McDonald's Old Town MRP
Variance Option 1
Rec'd. 12/31/13

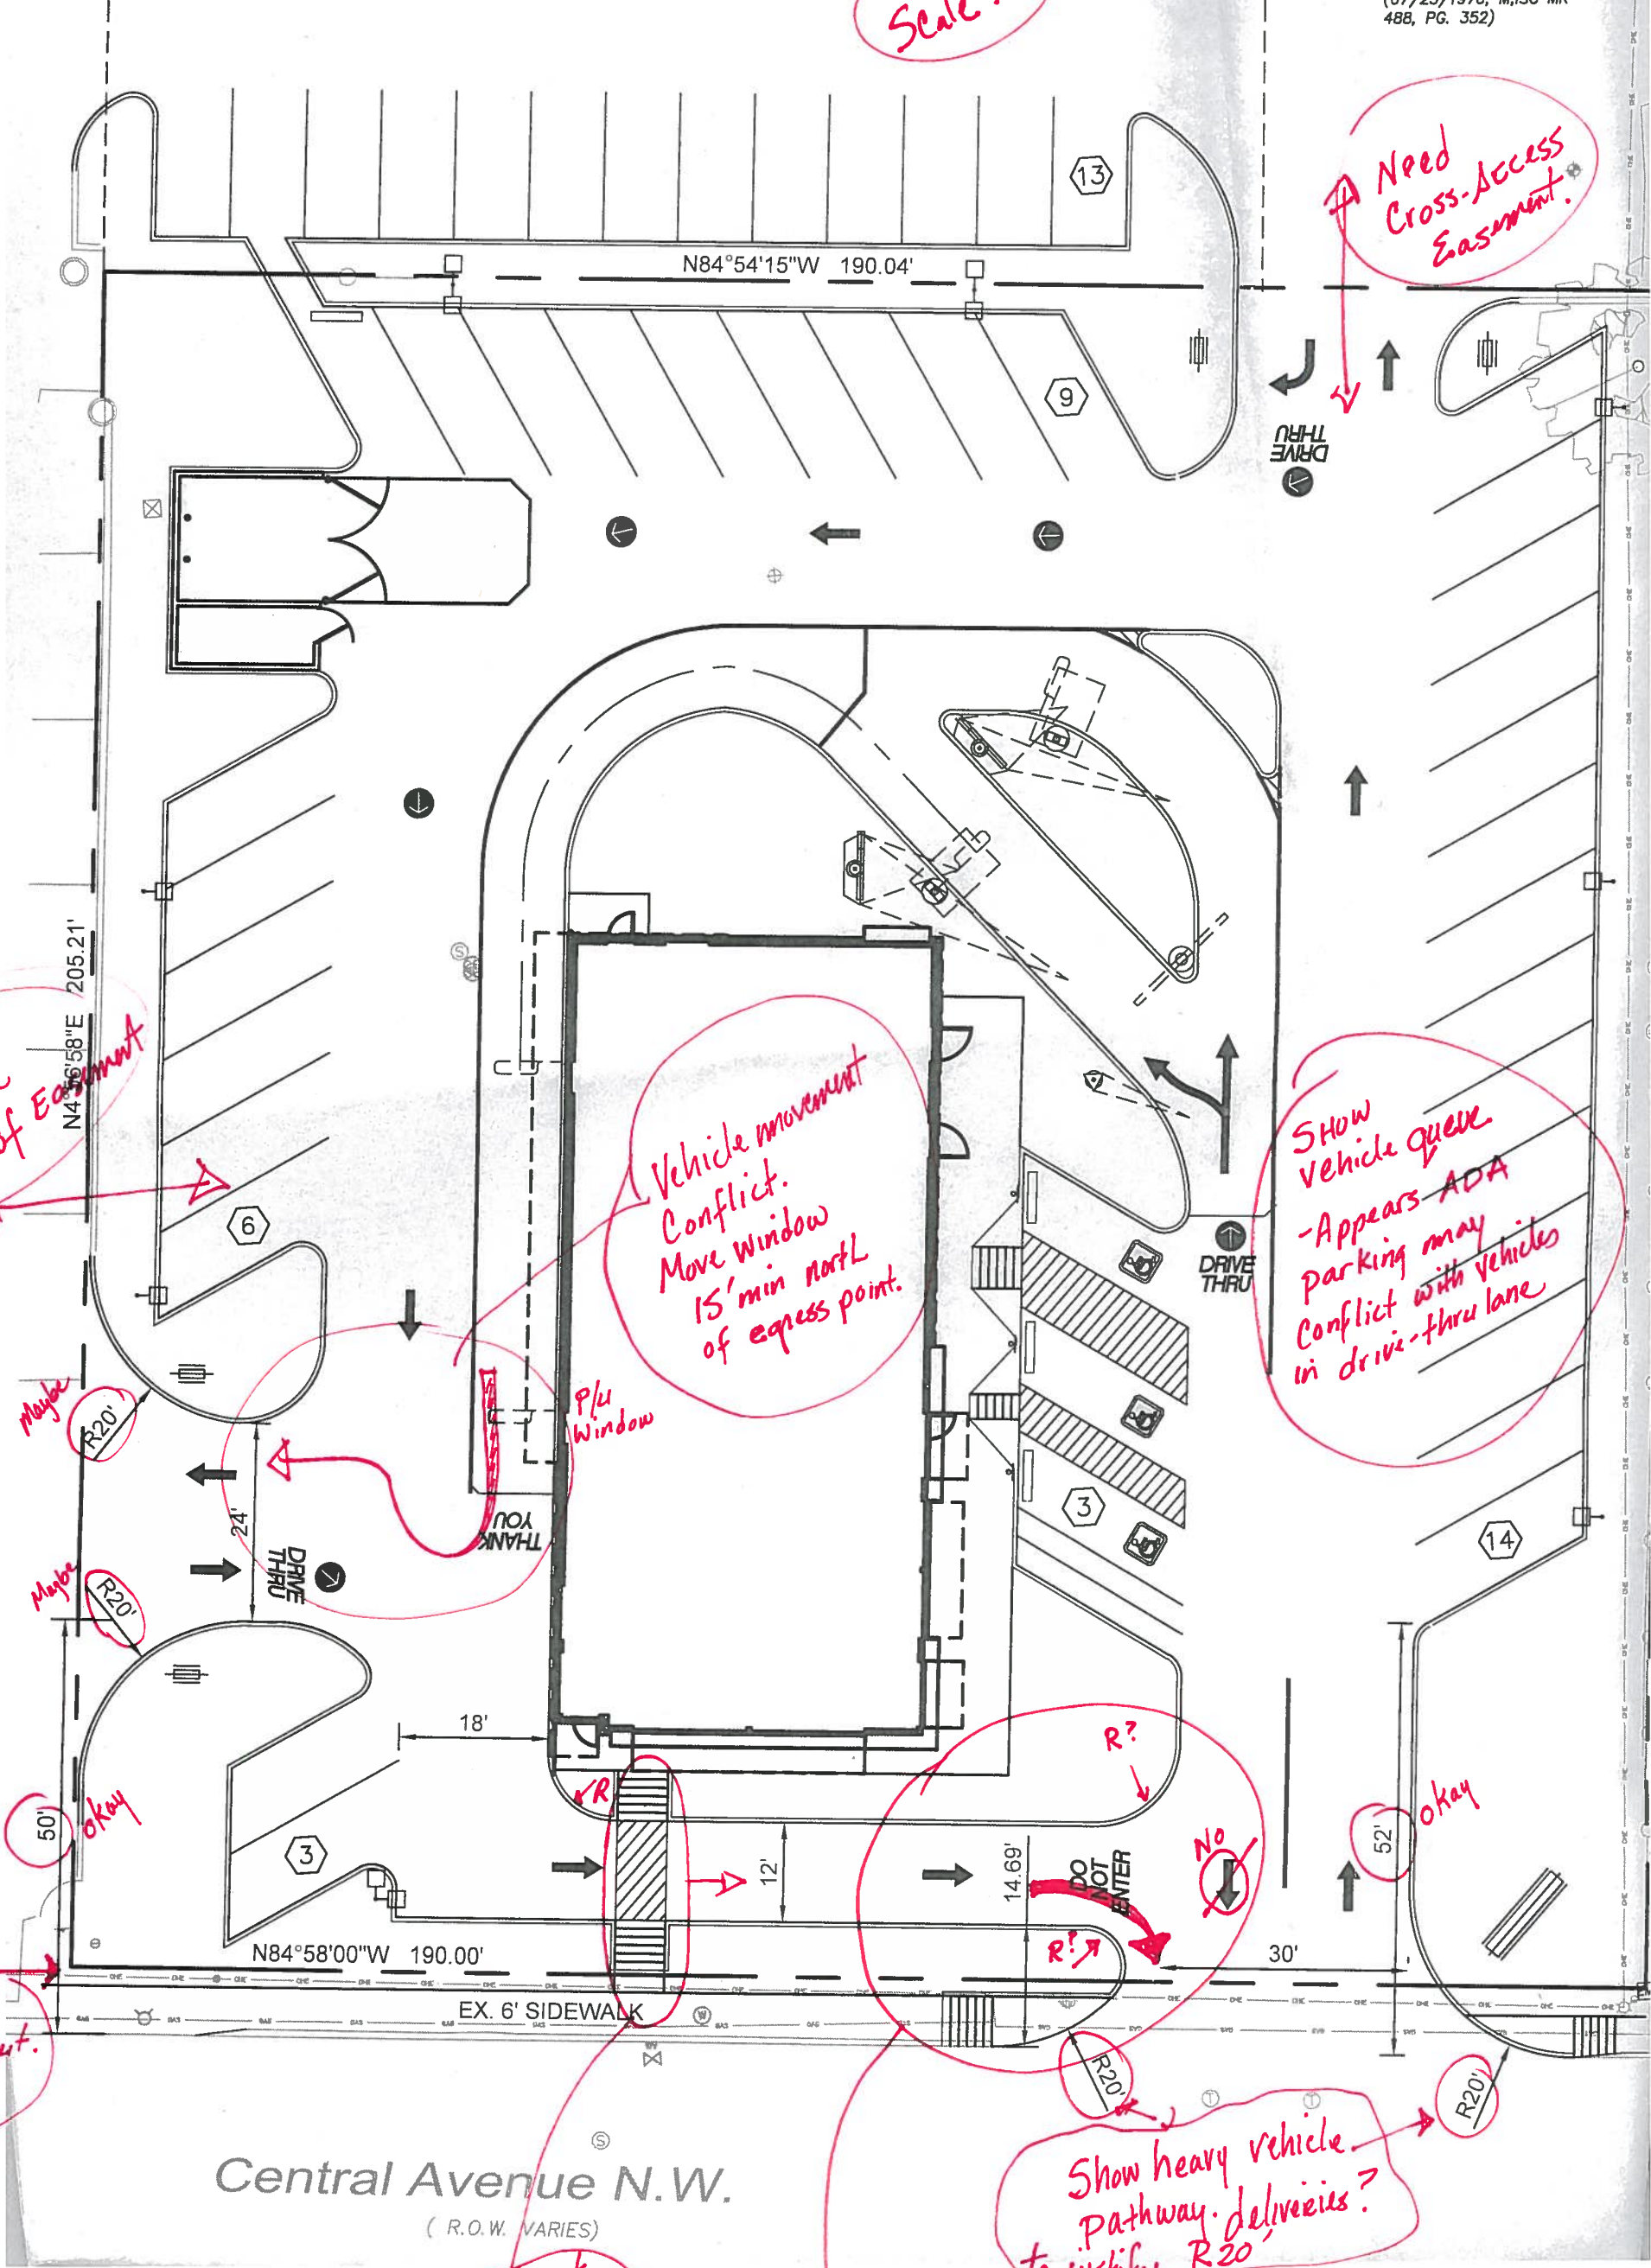
Suggest
relocating
further east
conflicts

Show heavy vehicle
pathway deliveries?
to justify R20

Conflict
Turn/U-turn: hard to maneuver
- too close to street
- hazard for pedestrians
- driver cannot see - position of angle
- vehicle pathway difficult
- Show template.
